DESCRIPTIVE REPORT

Registry No. H-11110

General Locality Sitka Sound to Peril Strait

Revisions Compiled During Office processing and Certification.

Figure 2. H11110 Junction Surveys.

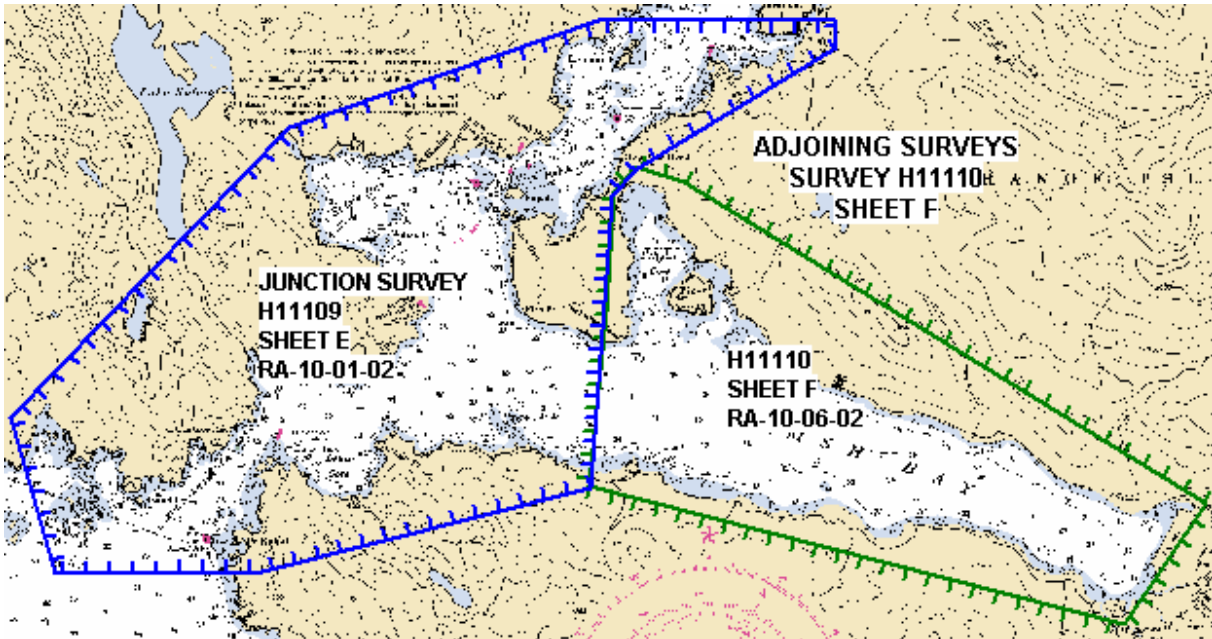
At the time of this report, data processing for survey H11109 was not completed. Comparisons of the junction with this survey will be discussed in the Descriptive Report for H11109.⁷

Final comparisons will be made at the Pacific Hydrographic Branch (PHB) after the application of smooth tides.⁸

⁷ Concur, the junction with survey H11110 and H11109 is complete. A "Joins" note has been added to the smooth sheets where applicable.

⁸ Results of the comparison after applications of approved tides are considered good.

Figure 3. Pos. # 21782 – 211785, Ledge Disprovals.

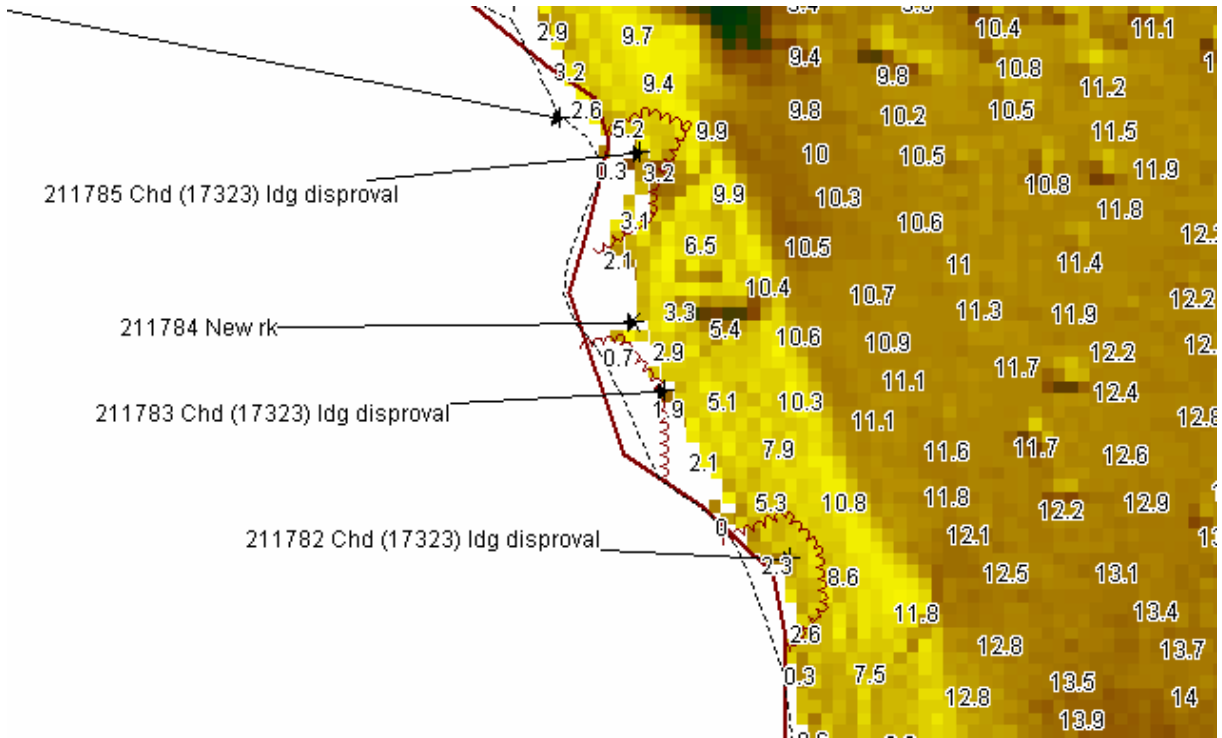
The charted (17323) ledge at 57°23'46.01"N, 135°36'18.64"W (Position # 211782; 463,629 E, 6,361,643 N) was disproved by conducting a five-minute visual search within a search radius of twenty meters. Sea conditions were flat. Water visibility in this area was clear to the bottom to a depth of three meters. There is a VBES shoreline buffer (Line # 001_1526, VN 2122, DN 117) and 100% SWMB coverage (Line # 287_0021, VN 2124, DN 131) over the ledge deep enough for safe vessel navigation. See Figure 3 below. The Hydrographer recommends removing this ledge from the chart.³⁰

The charted (17323) ledge at 57°23'48.31"N, 135°36'21.93"W (Position # 211783; 463,578 E, 6,361,711 N) was disproved by conducting a five-minute visual search within a search radius of twenty meters. Sea conditions were flat. Water visibility in this area was clear to the bottom to a depth of three meters. There is VBES shoreline buffer (Line # 001_1526, VN 2122, DN 117) and 100 meter VBES line spacing (Line # 185_2321, VN 2122, DN 117) over the ledge. See Figure 3 below. The Hydrographer recommends removing this ledge from the chart.³¹

The charted (17323) ledge at 57°23'51.34"N, 135°36'22.4"W (Position # 211785; 463,567 E, 6,361,808 N) was disproved by conducting a five-minute visual search within a search radius of twenty meters. Sea conditions were flat. Water visibility in this area was clear to the bottom to a depth of three meters. There is a VBES shoreline buffer (Line # 001_1526, VN 2122, DN 117) and 100 meter VBES line spacing over the ledge (184_2320, VN 2122, DN 117). There is 100% SWMB coverage (Line # 286_2147, VN 2124, DN 131) over the ledge deep enough for safe vessel navigation. See Figure 3 below. The Hydrographer recommends removing this ledge from the chart.³²

³⁰ Concur

³¹ Concur

³² Concur

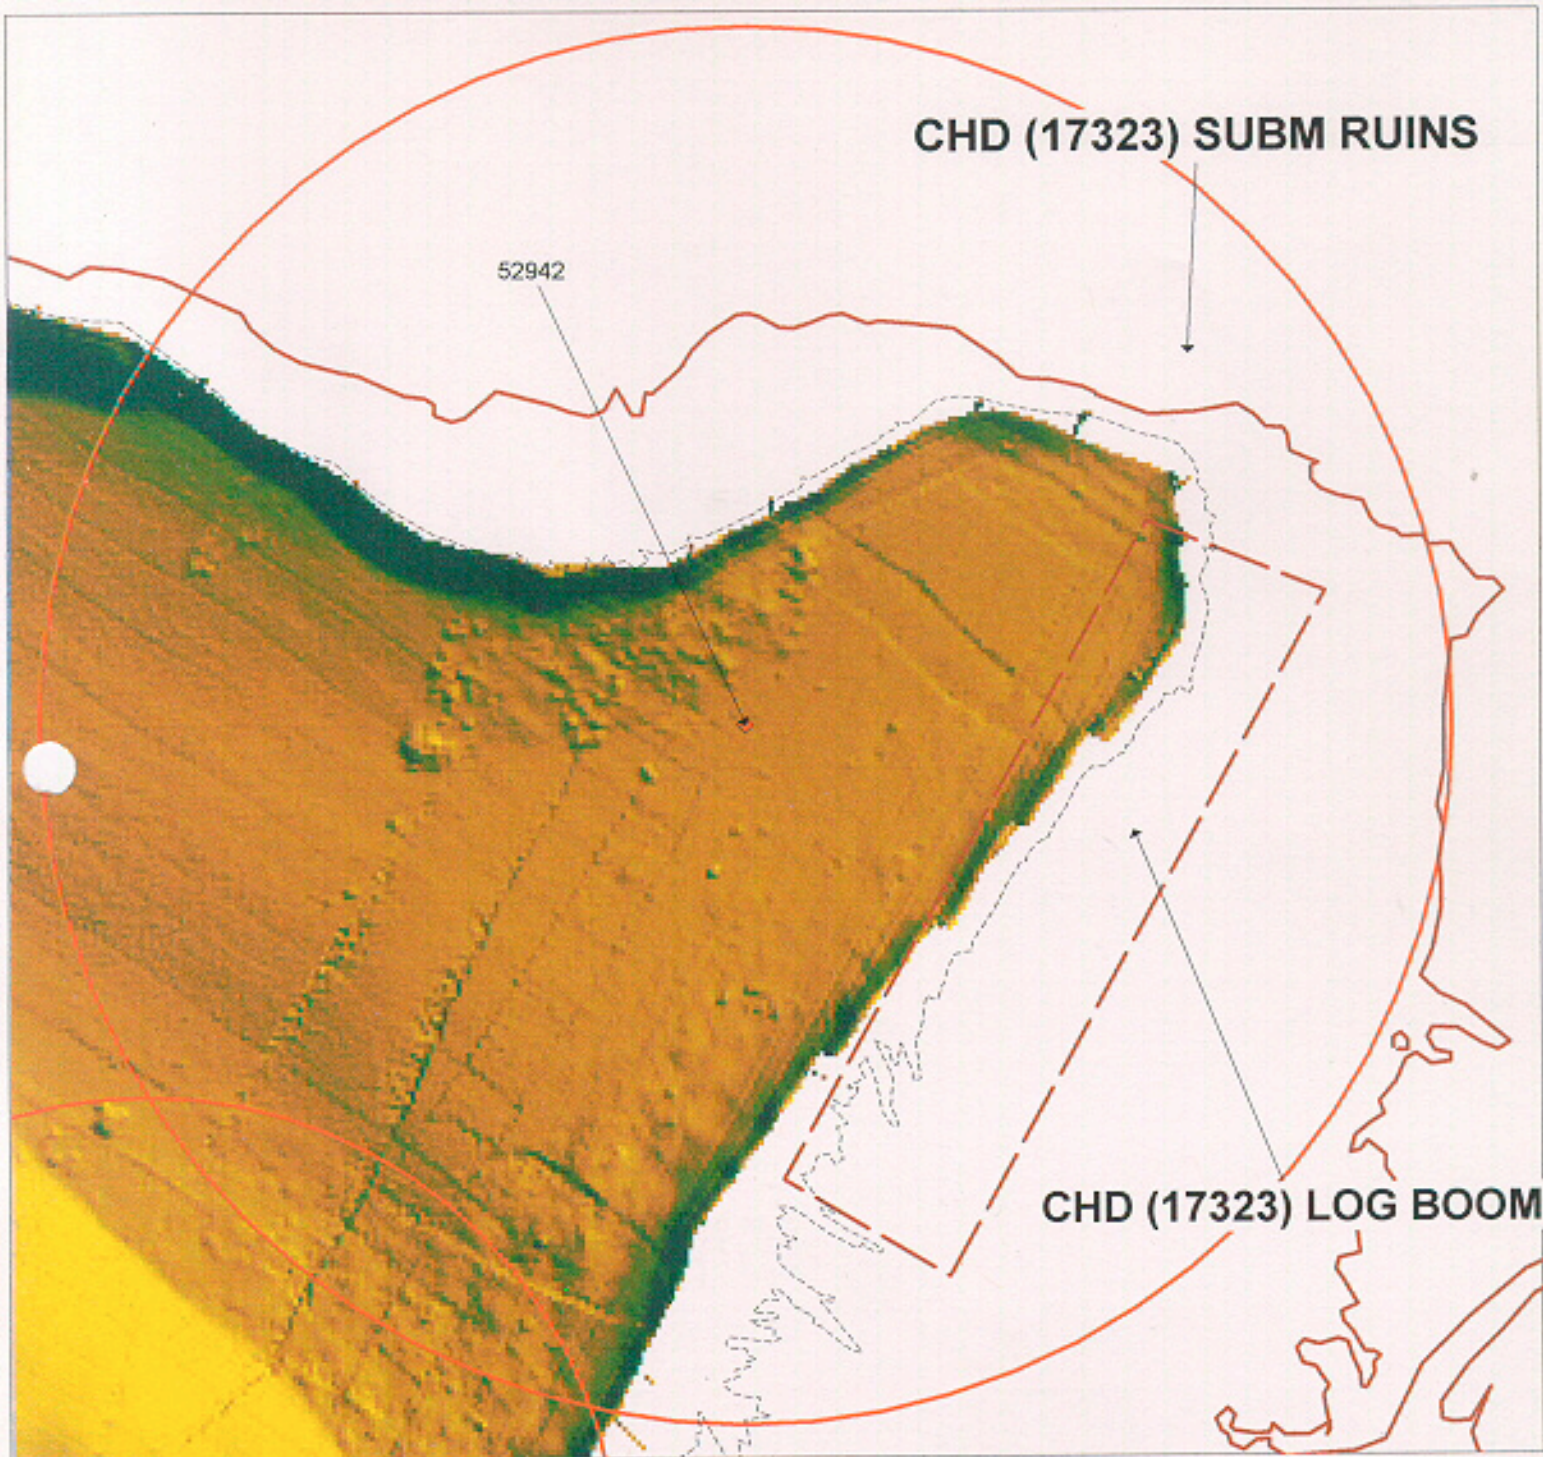
Fieldnote
INVESTIGATION
DATE(S): 4/27/02 - 5/23/02 (DN: 117, 135, 143)
HYDROGRAPHIC SURVEY NUMBER: H11110
VN: 2122, 2124, 2125
INVESTIGATION METHODS USED: (IE DI, 200% SIDE SCAN SONAR, ECHO SOUNDER) A visual search was conducted during shoreline verification. One hundred meter VBES line spacing was conducted in the area and 100% SWMB coverage was obtained where possible.
POSITION DETERMINED BY: DIFFERENTIAL GPS
INVESTIGATION SUMMARY: A 10 minute visual search was conducted at low water. One hundred percent SWMB coverage was obtained over the northwestern corner and along the western side of the charted (17323) log storage, and throughout the assigned search radius deep enough for safe vessel navigation. The Department of Natural Resources of the State of Alaska was contacted in order to find the status of this log storage area. They responded in a letter saying, ". . .that there currently are no legally authorized Log Storage operations at . . . Fish Bay." See attached letter in hard copy form. No sign was seen of the charted (17323) ruins with one hundred percent SWMB.

CHARTING RECOMMENDATION (HYDROGRAPHER): The Hydrographer recommends removal of the charted (17323) log storage area.
EVALUATOR COMMENTS:Concur
